6.4 LATE ITEM - PLN15/1176.02 - 2 Gough Street, Cremorne

1. This report provides Council with an assessment of planning permit application PLN15/1176.02 being an amendment to Stage 2 of the overall Nylex Silos redevelopment. The subject site is 2 Gough Street, Cremorne and recommends approval subject to conditions.

Ward: Melba Ward
Proposal: Amendment to the endorsed plans and permit conditions of PLN15/1176 including:

Figure 51 - Proposed north elevation

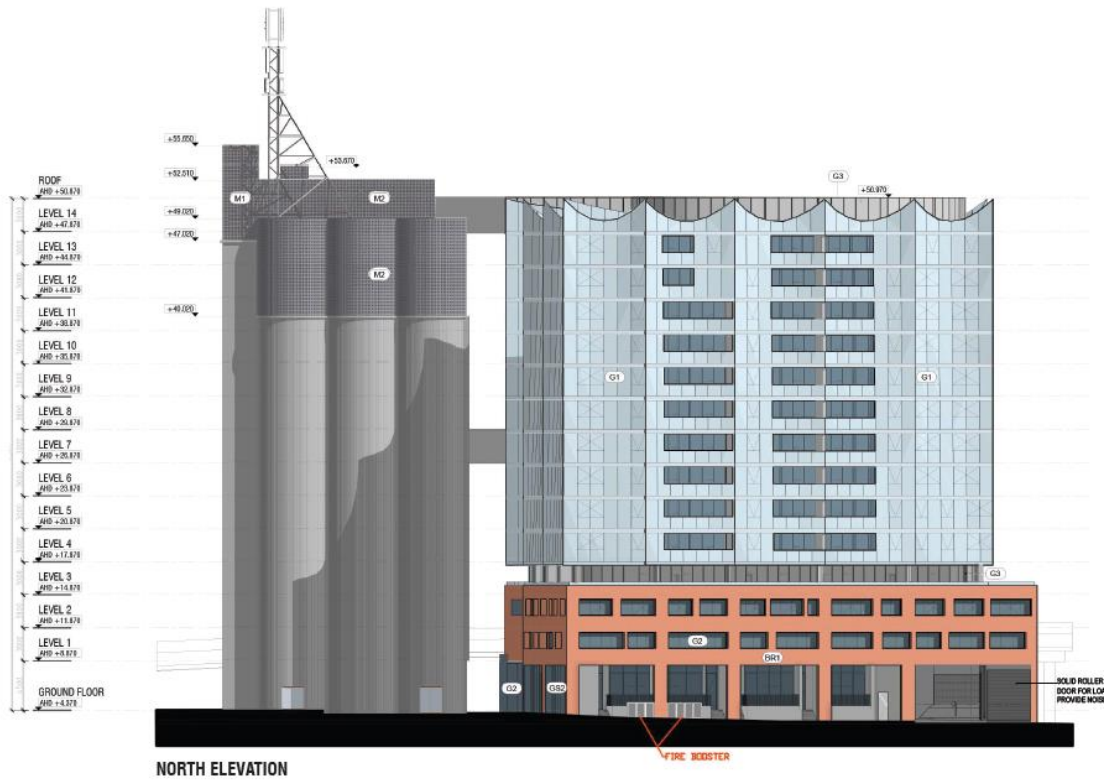
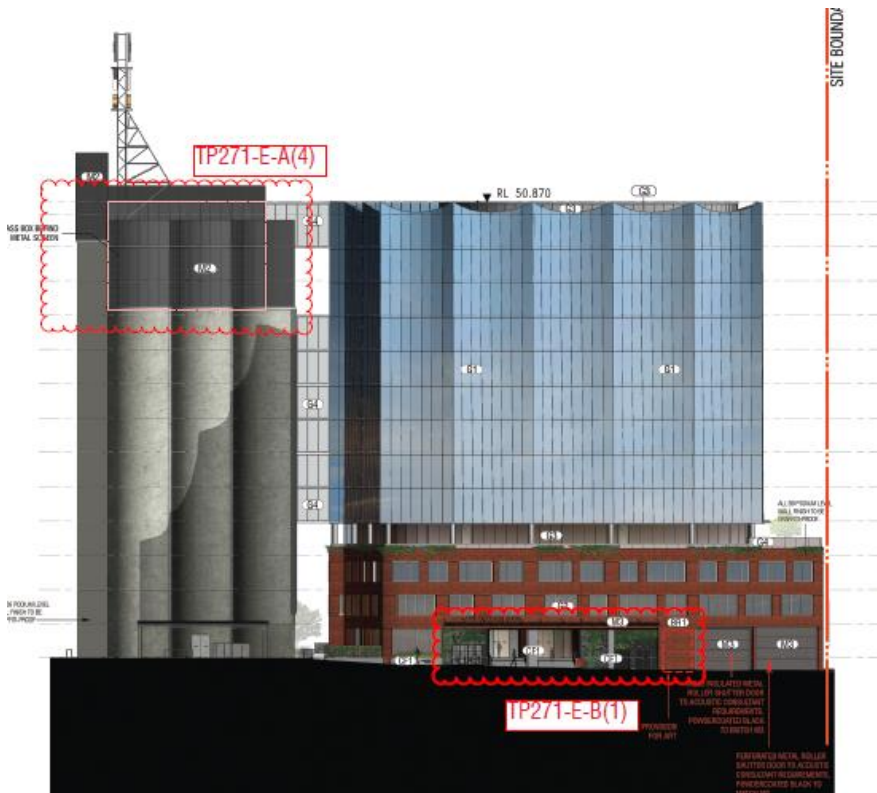
- 262. As a result of the change in use from a predominantly residential building to a commercial building, the fenestration has changed to accommodate a different use.
- 263. The architecture has deleted open balconies and operable windows and now proposes a curtain glass wall retaining the scalloped edges of the building.
- 264. It is noted that Council’s urban design was somewhat critical of the occupation of the vacant spaces previously allocated as balconies for the associated dwellings, however the design response accommodating a different use within the same building typology is considered acceptable.

265. The overall height of the building has been generally retained albeit the number of floors have been reduced due to the increased floor to ceiling clearances required for a commercial use as opposed to a residential use.
